04. DESIGN PROPOSAL

PROPOSED SCHEME, SW & NE ELEVATIONS

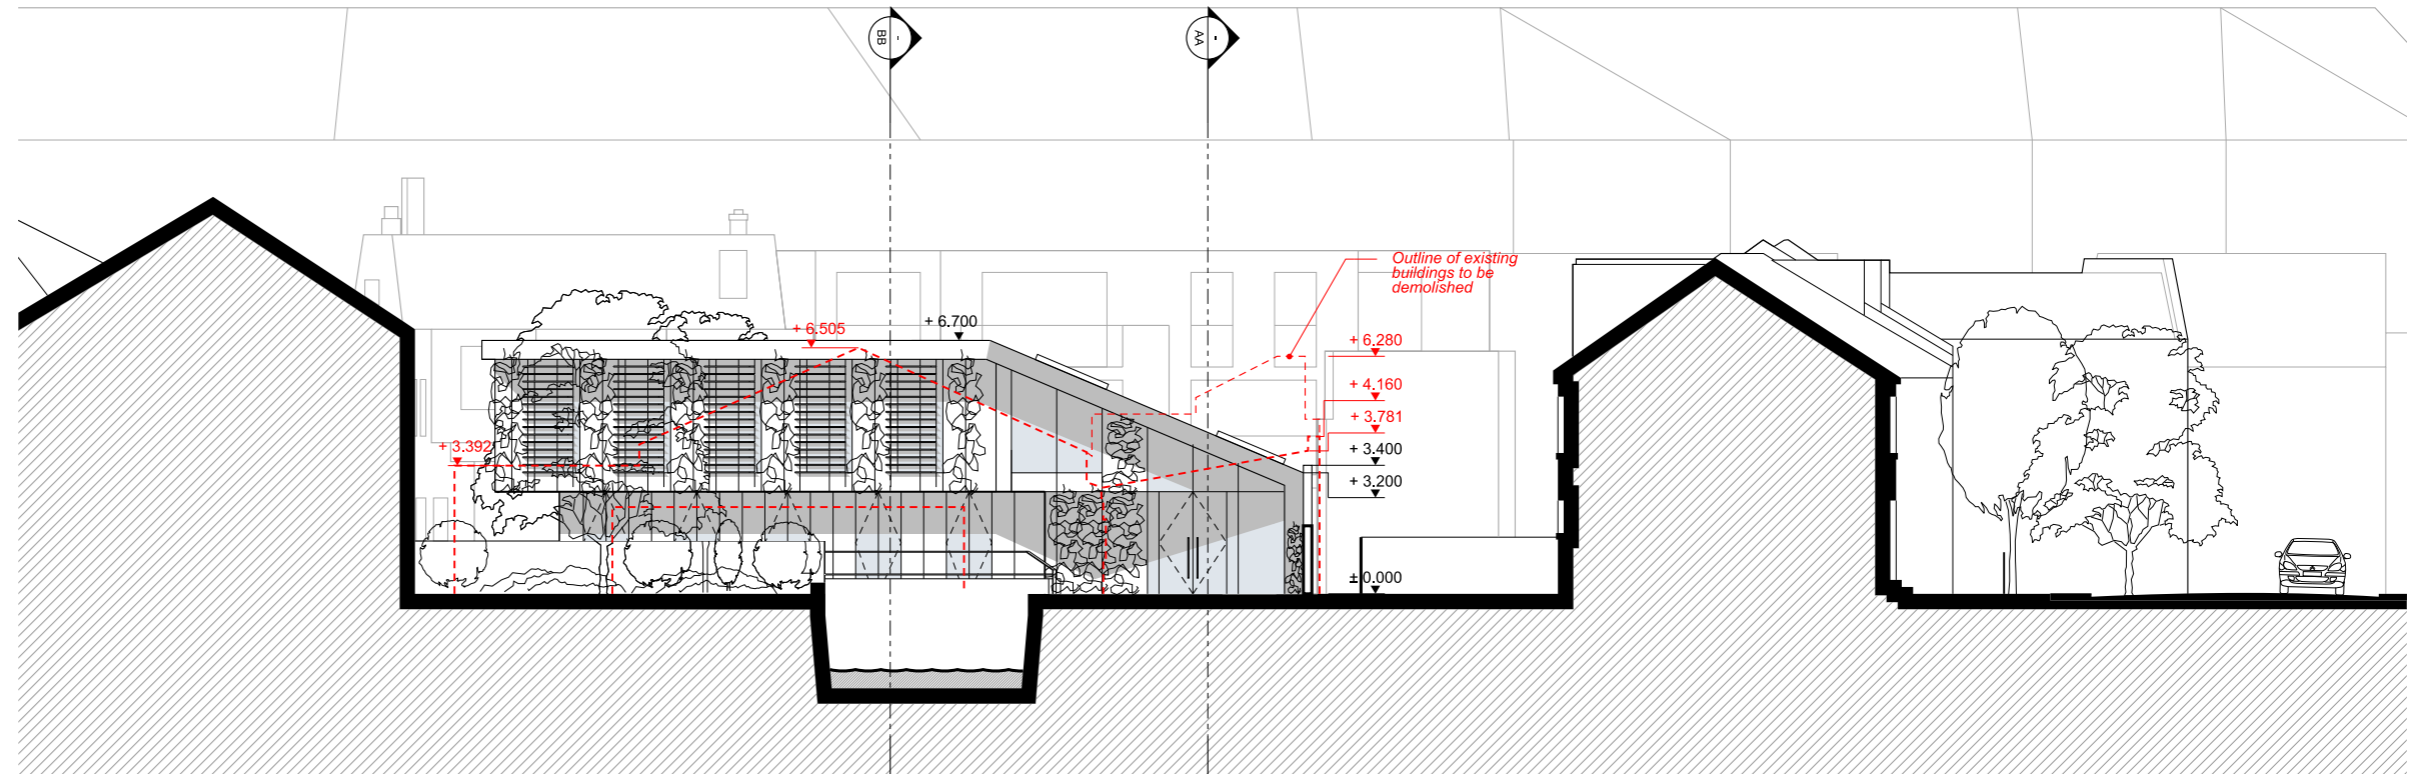
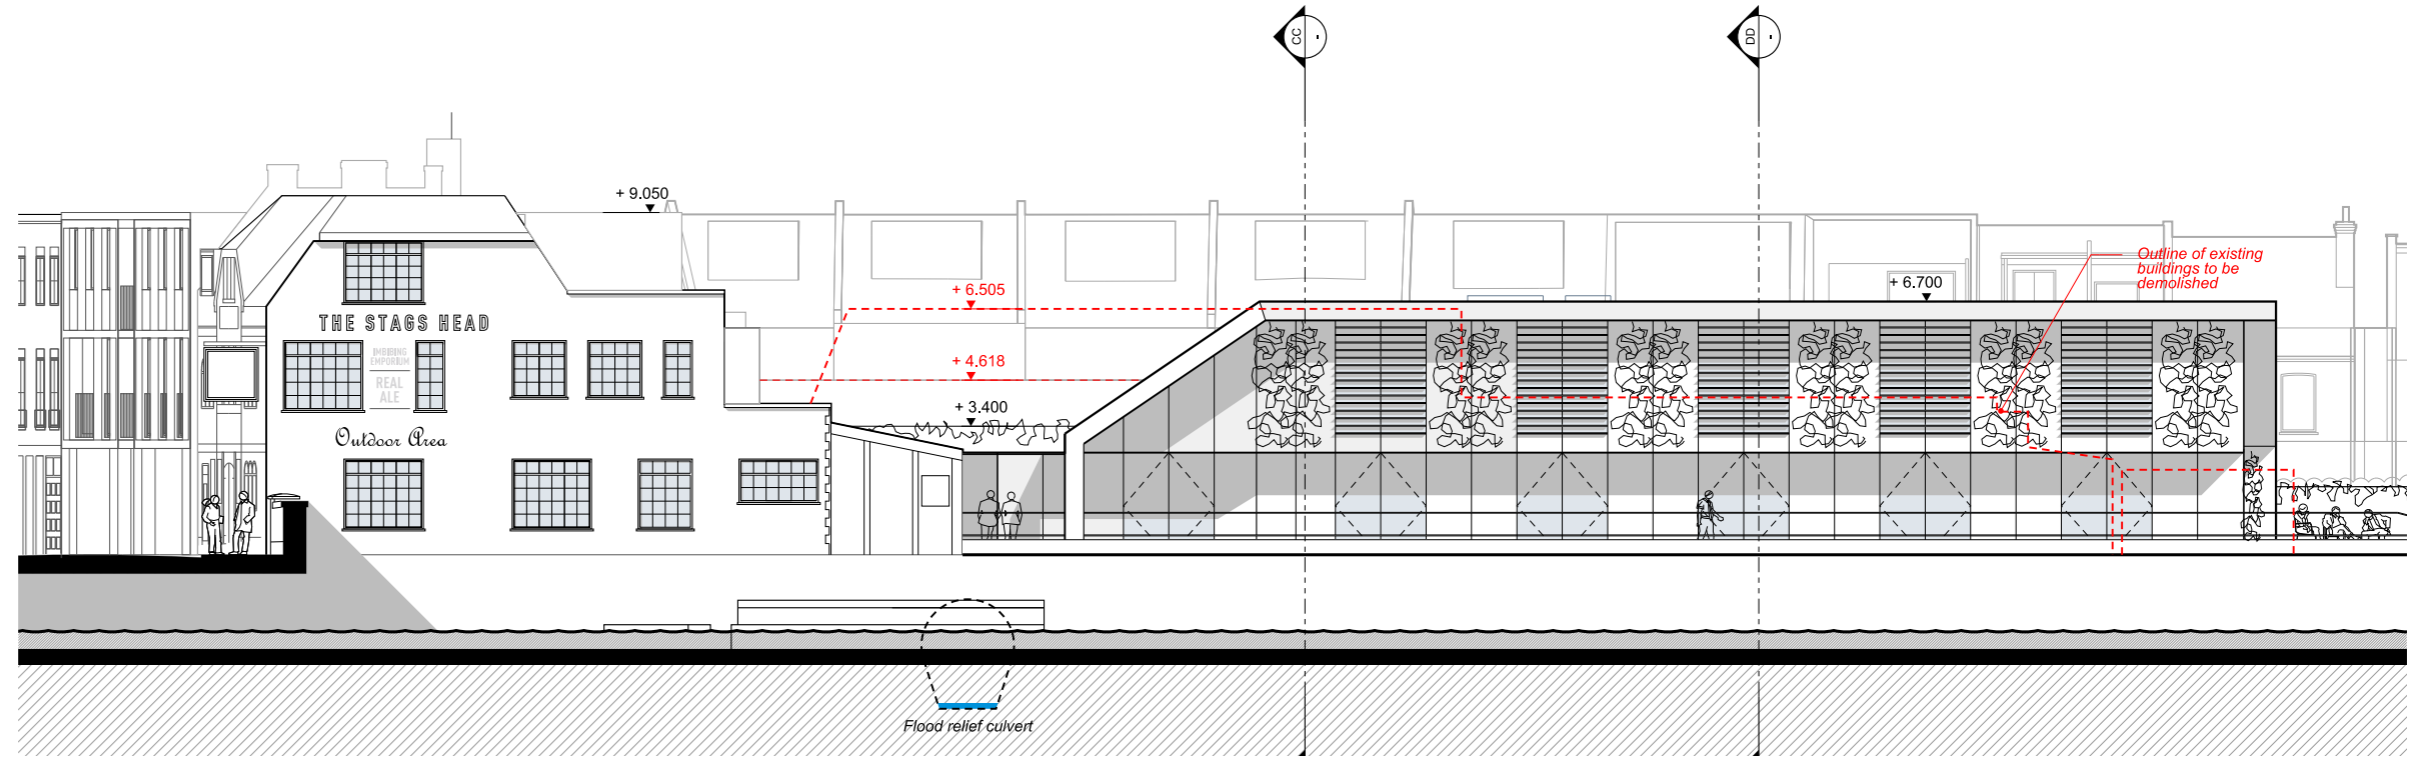
- 01 Air source heat pumps at roof level
- 02 Two additional car parking spaces provided for residential use.

PROPOSED SCHEME, NE & SE ELEVATIONS

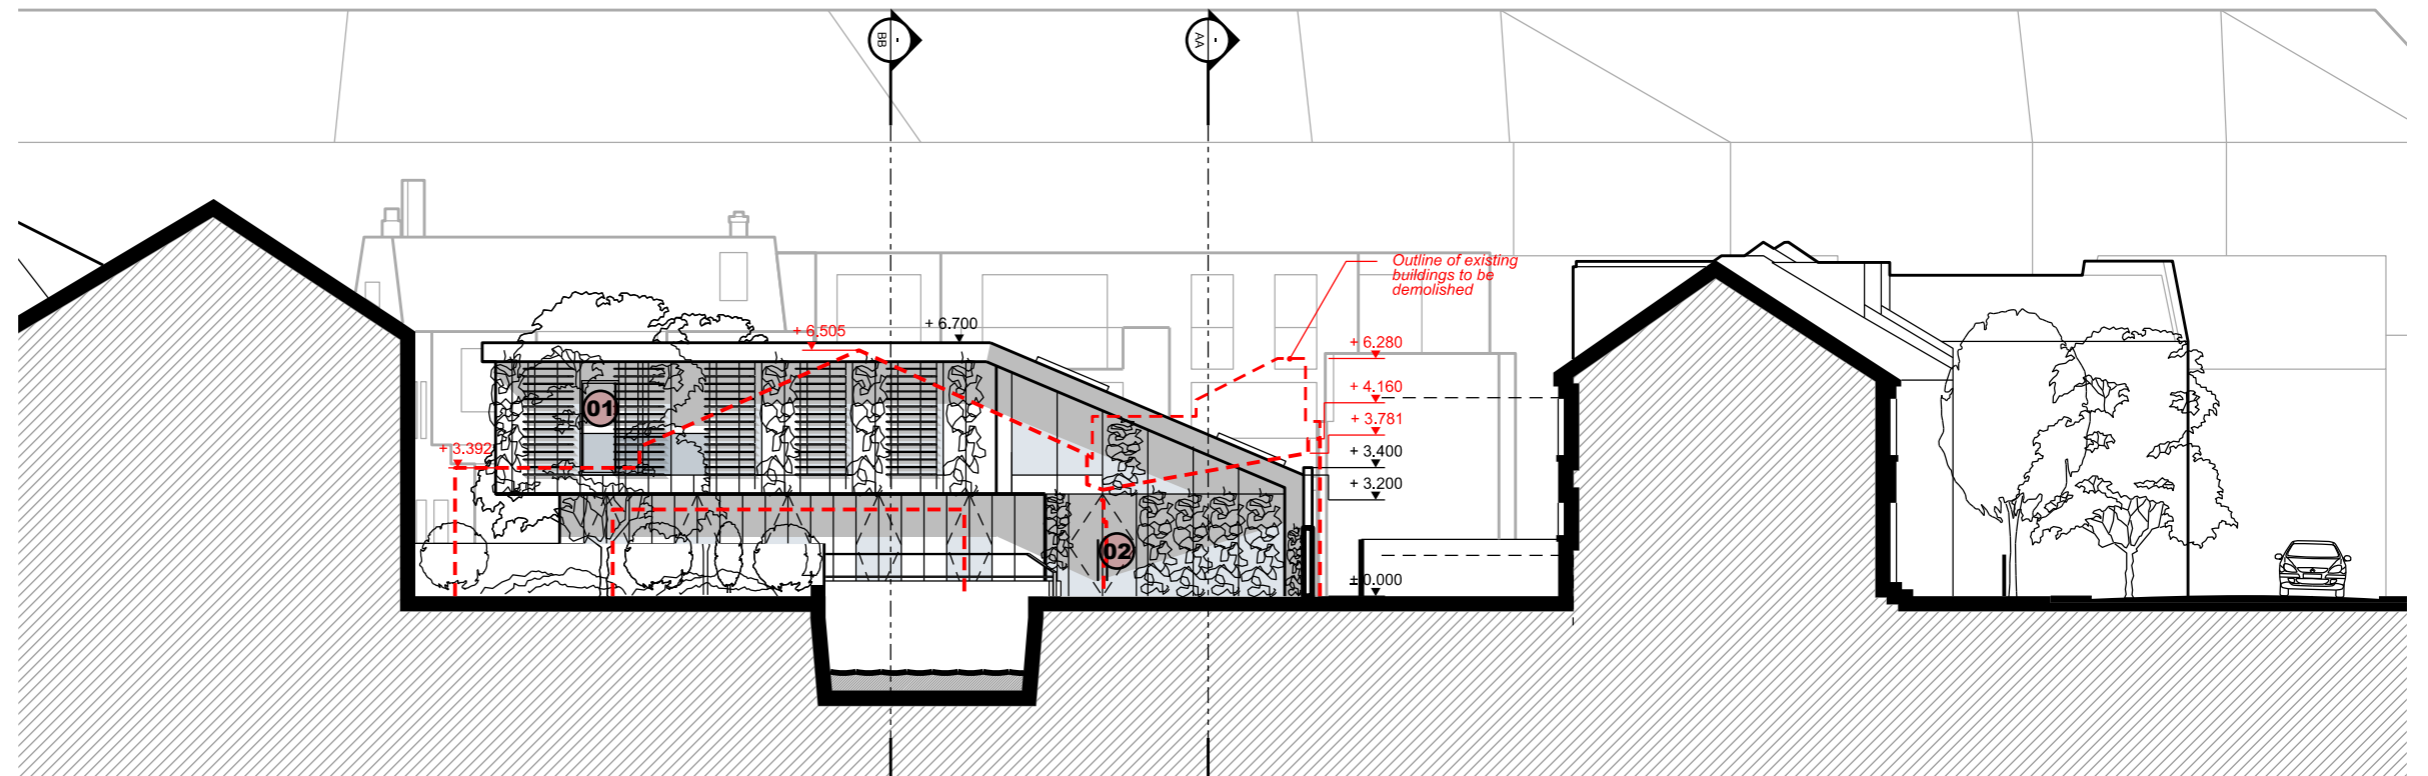
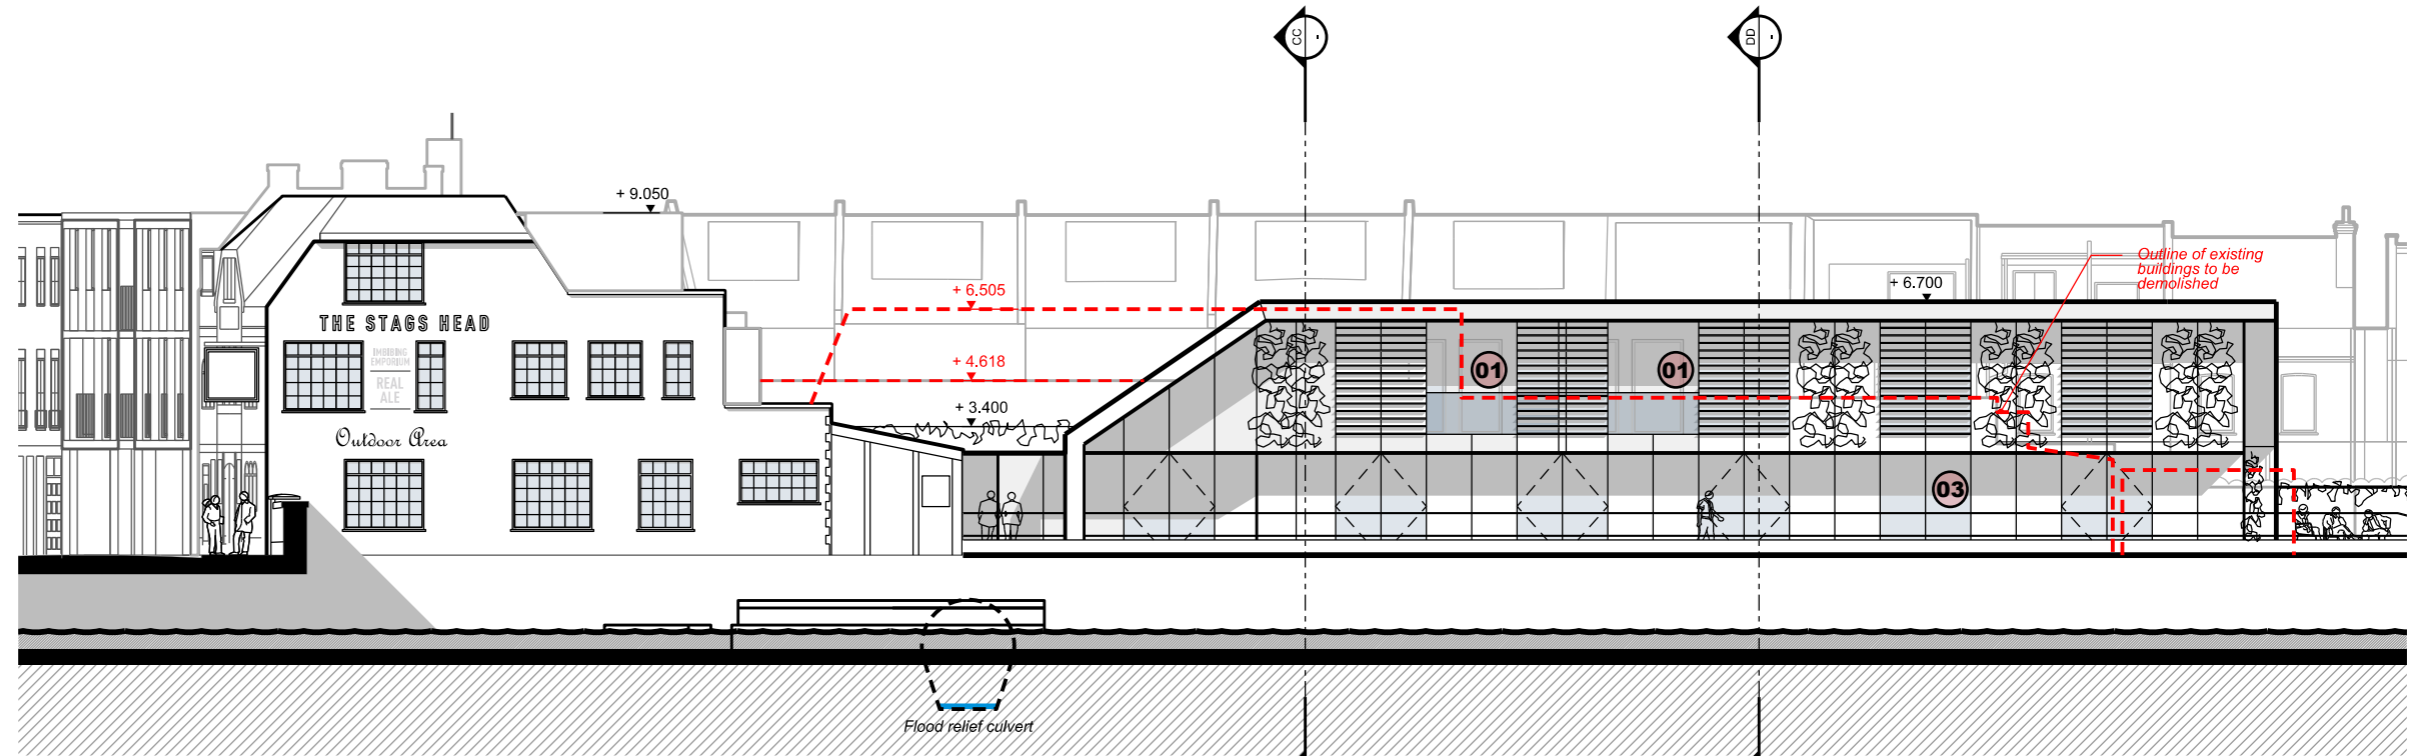
01 Glass balustrades in balconies for residential units at first level.

02 Access to the terrace to the rear of the site moved due to internal layout changes.

03 Window instead of a door.

PROPOSED SCHEME, SW & NW ELEVATIONS

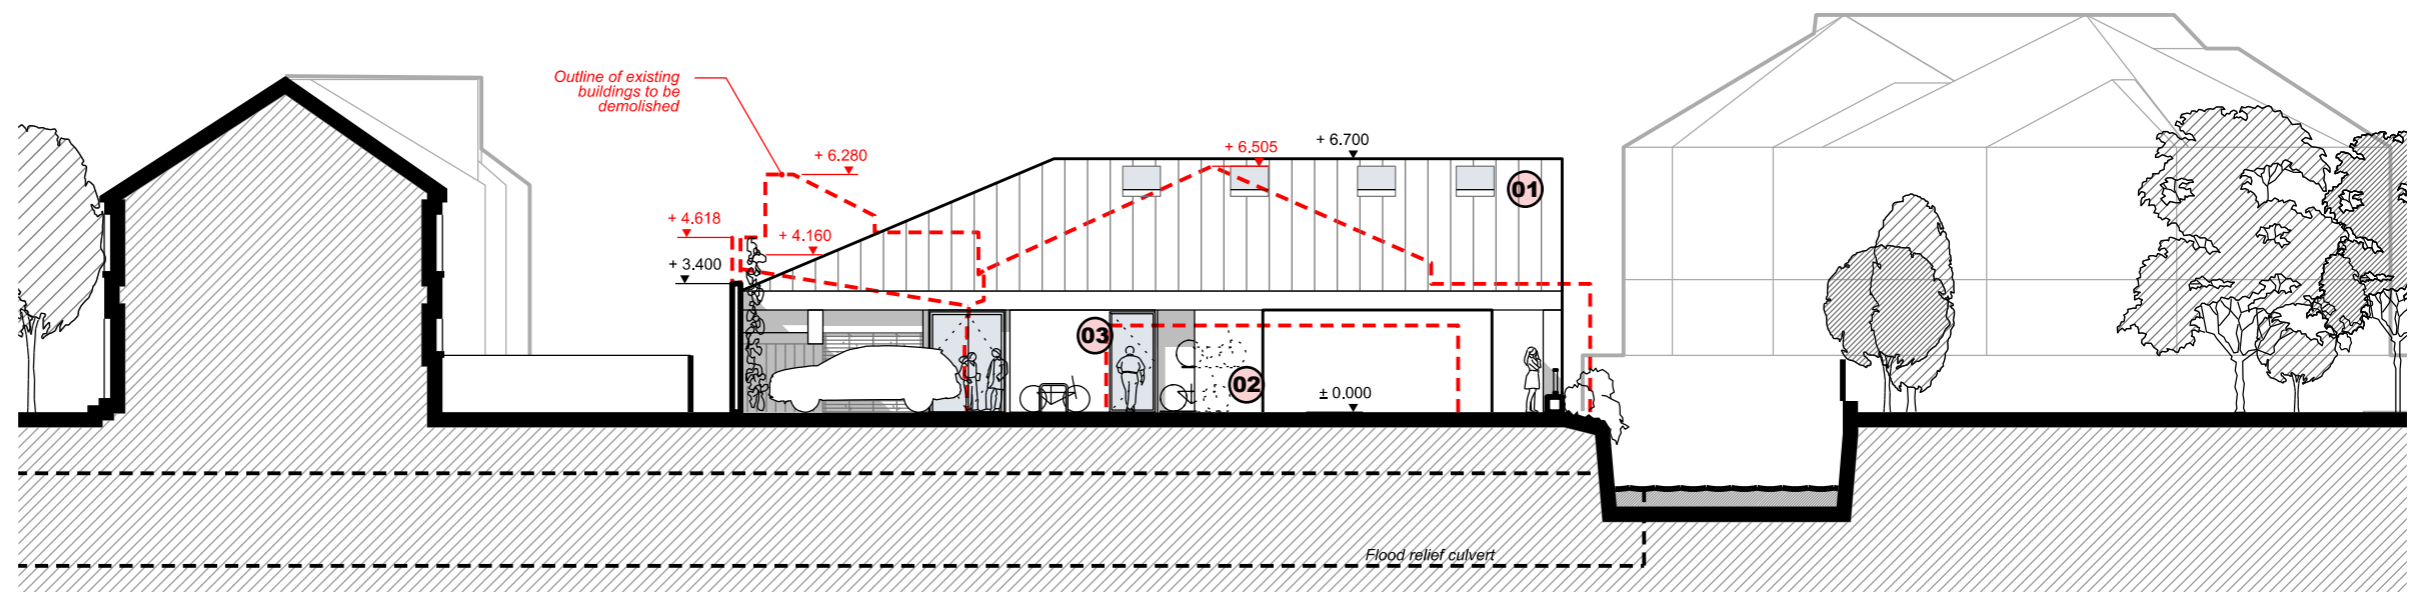
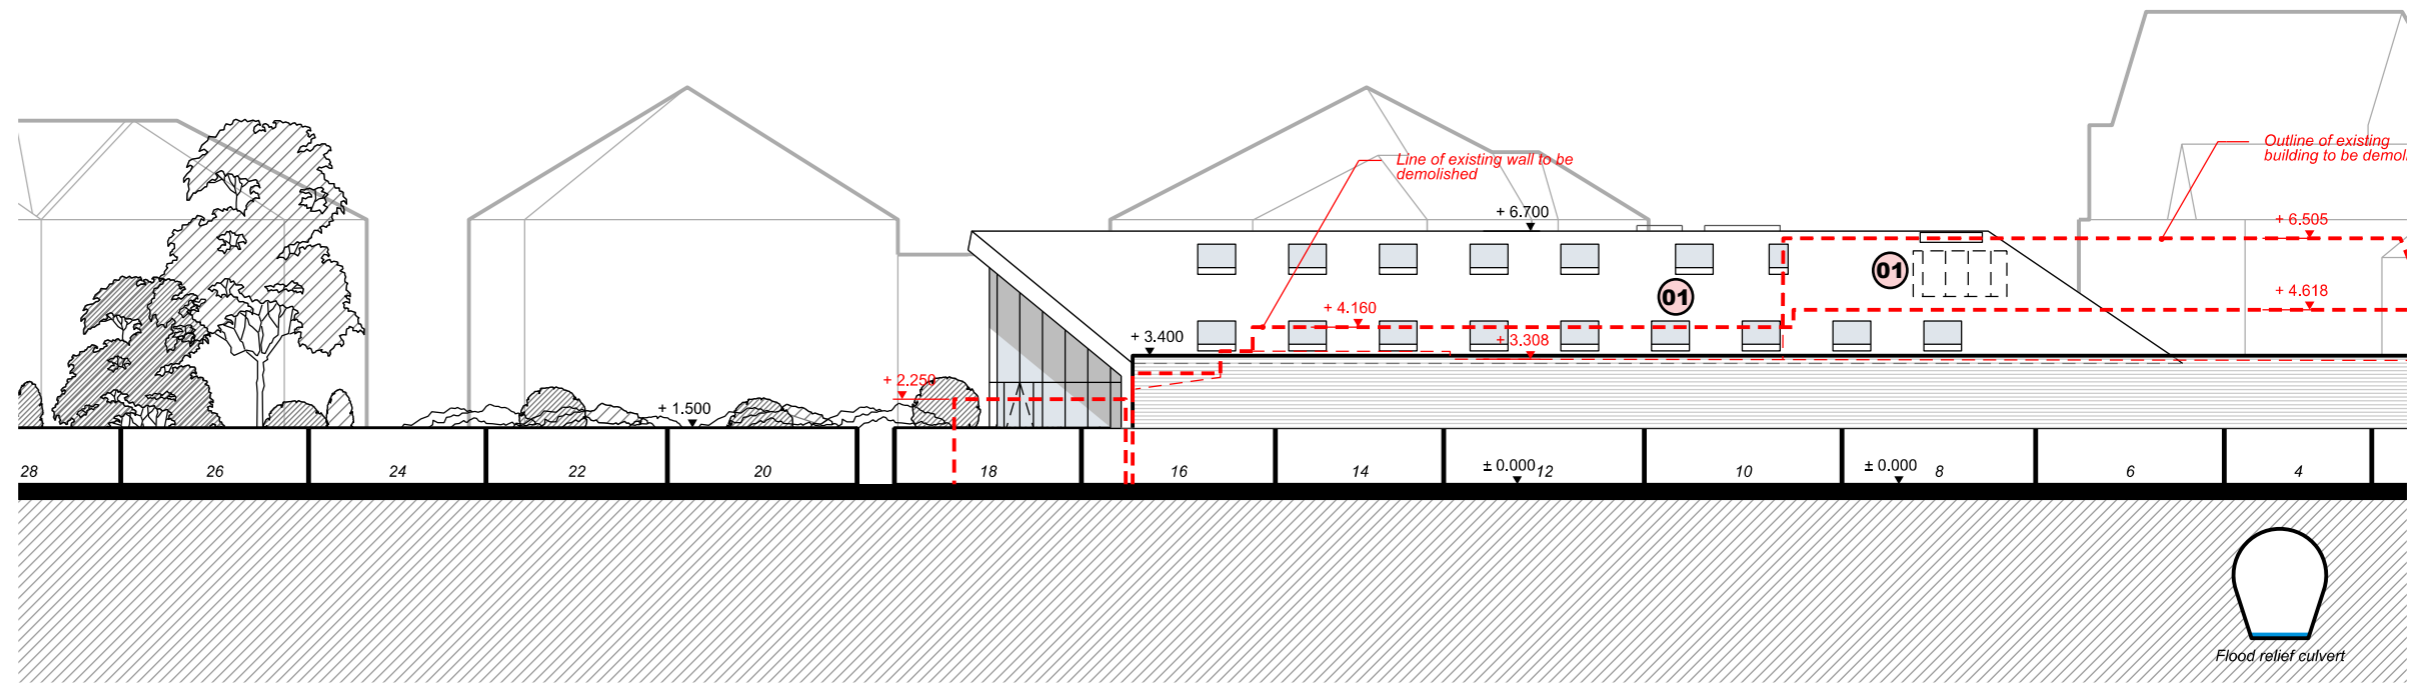
01 Rooflight and plant room louvres location modified.

02 Bin and bike storage reviewed to comply with regulations.

03 New shared entrance for commercial plant room and residential units at first floor level.
